From: Welch, Tim <Tim.Welch@terracon.com>
Sent: Thursday, May 13, 2021 3:20 PM
To: Schultz, Josie M - DNR
Cc: qefli neziri; Buc, Edmund A
Subject: #02-05-217270 OHM-Green Bay
Attachments: Martinizing SSDS & SSI Work Plan_05132021.pdf

RE: **SSDS Modifications & Supplemental Site Investigation Work Plan**
Martinizing Dry Cleaners and Laundry Services
1233 Military Avenue
Green Bay, Wisconsin
BRRTS #02-05-217270
Terracon Project No. 58217038

SUB-SLAB VAPOR MITIGATION SYSTEM DIAGRAM

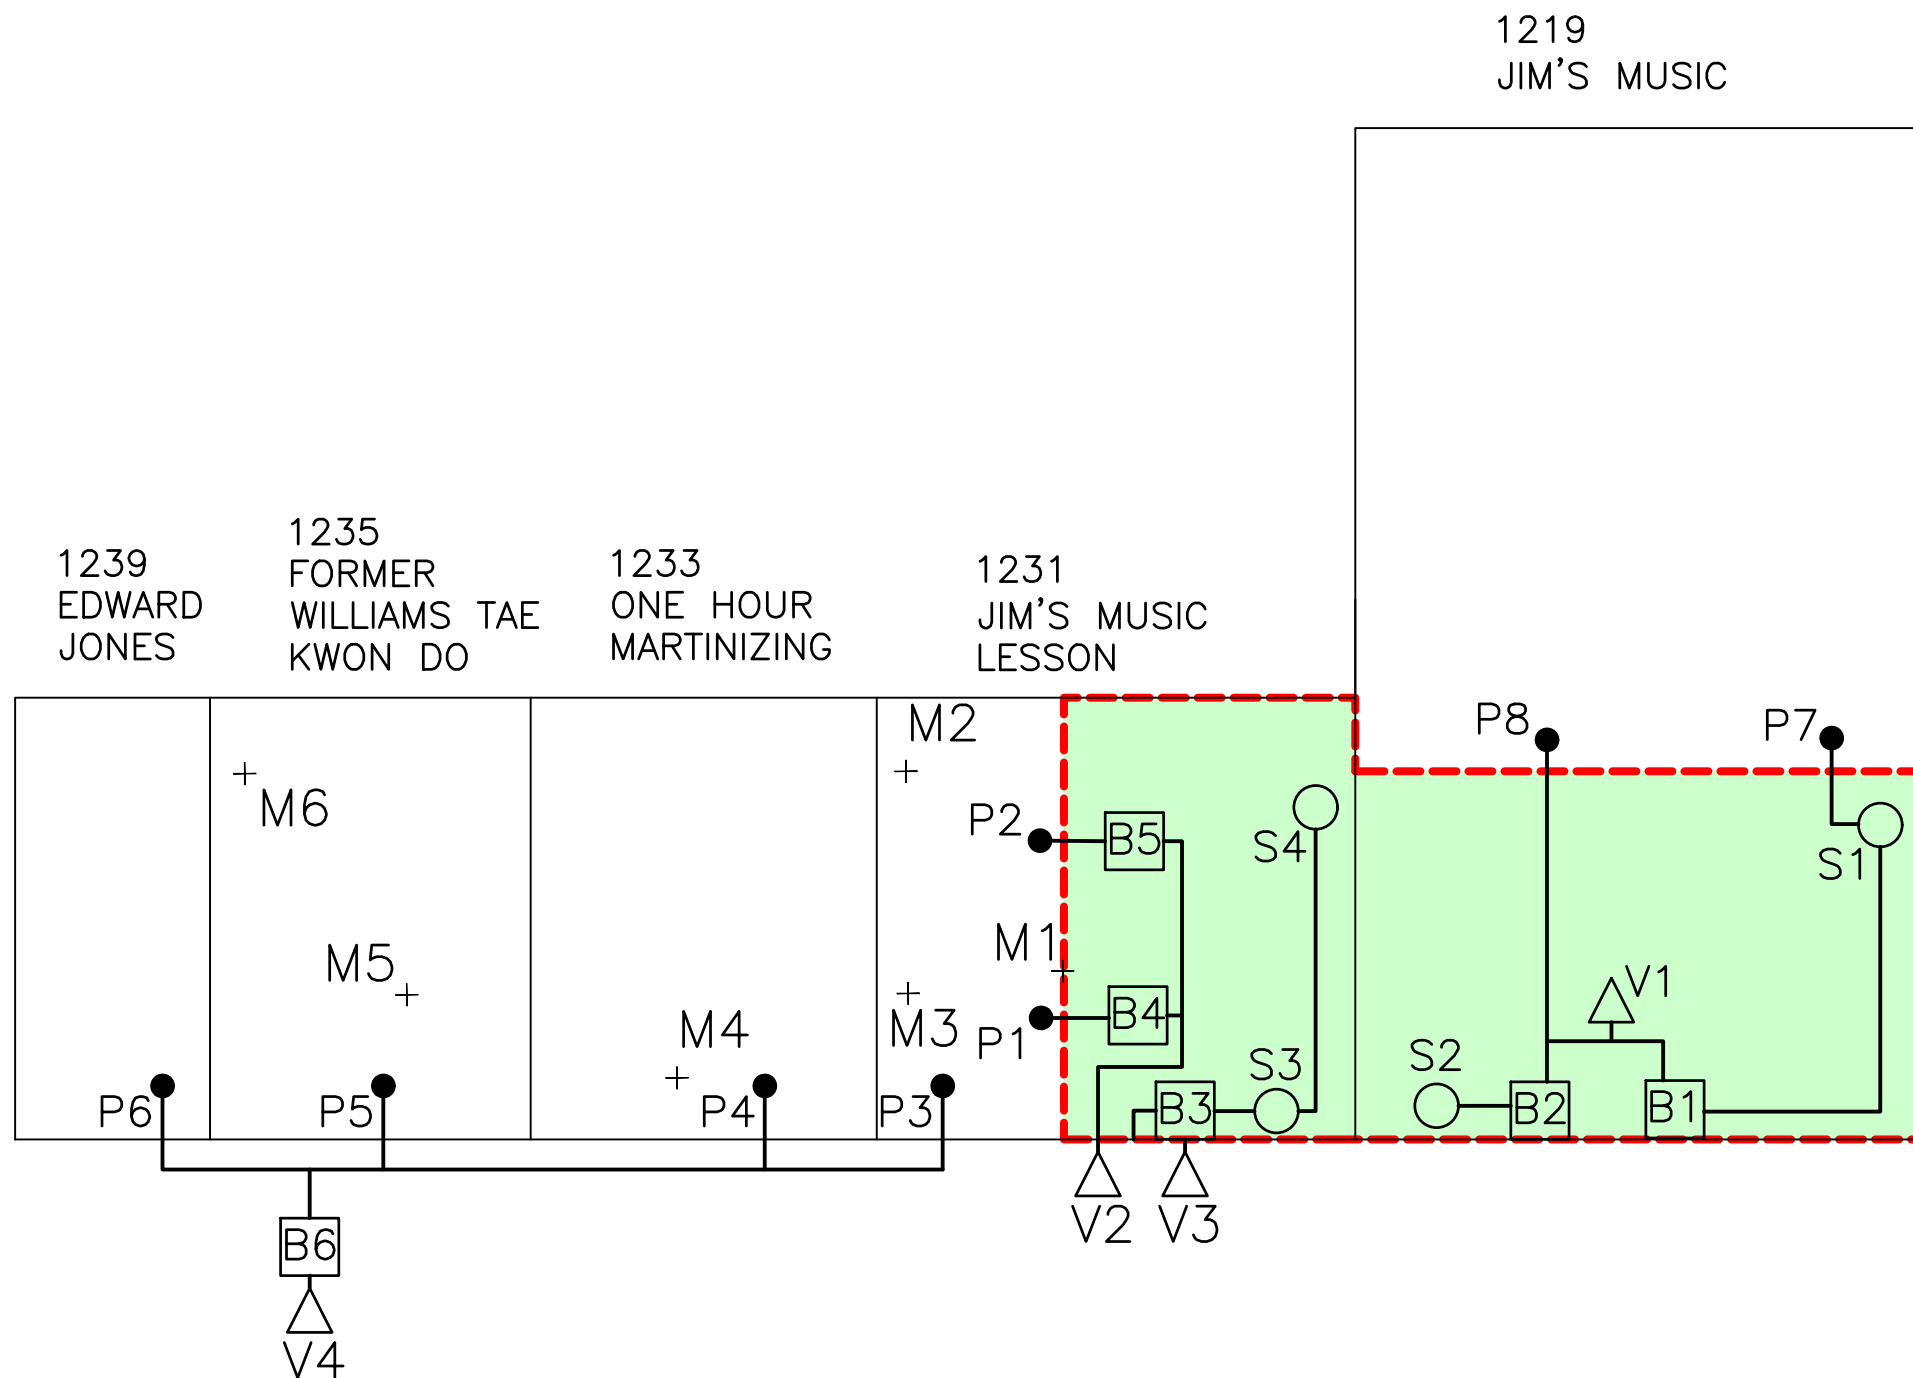
- Interim Action Design Concerns- Eleven (11) deviations from American Nation Standards Institute & American Association of Radon Scientists and Technologists (ANSI/AARST) standards were listed as potentially not met;

- Commissioning Requirements- Along with the listed ANSI/AARST standards not met, the SSDS has not been properly commissioned to verify the effectiveness of the mitigation. Proper PFE has not been performed to ensure good communication and vapor capture beneath the slab;

- Timeline- 1) The new blower fan should be installed, and VMS inspected, by November 6, 2020. Additional commissioning of the system, including PFE testing, fan vacuum readings, and smoke/tracer testing should be performed during this time, 2) Plumbing should be corrected (i.e., removal of vent from sanitary lateral), VMS be brought up to

ANSI/AARST standards, and recommended tracer testing be performed to ensure no short-circuiting is occurring, by November 30, 2020, 3) Indoor air sampling, as part of the commissioning process and performance verification, should be completed concurrent with PFE measurements, or within two weeks, and results provided to the DNR within 10 days, and 4) Documentation and/or addendum to vapor mitigation system construction documentation should be submitted to the WDNR by December 30, 2020.

- "Relocate all basement fans to the building exterior. This will include adding three new vent lines to the exterior of the building so each system has its own fan.
- Rebuild vent lines to eliminate water traps. If water traps are unavoidable, install measures to ensure moisture does not build up in the system.
- Remove vent line tied into sewer vent. Repair sewer vent pipe. Install new dedicated vent lines for sub-slab systems.
- Ensure sump lids are sealed properly and include 4" mechanical access, viewing ports, and trapped drains to each lid.
- Assure the vent stack is at least 10' above grade and away from re-entrainment points.
- Install manometer differential pressure gauge on the systems to serve as an indicator of system operation and to measure system pressure.
- Address exposed channel drain to ensure it retains its waterproofing properties.
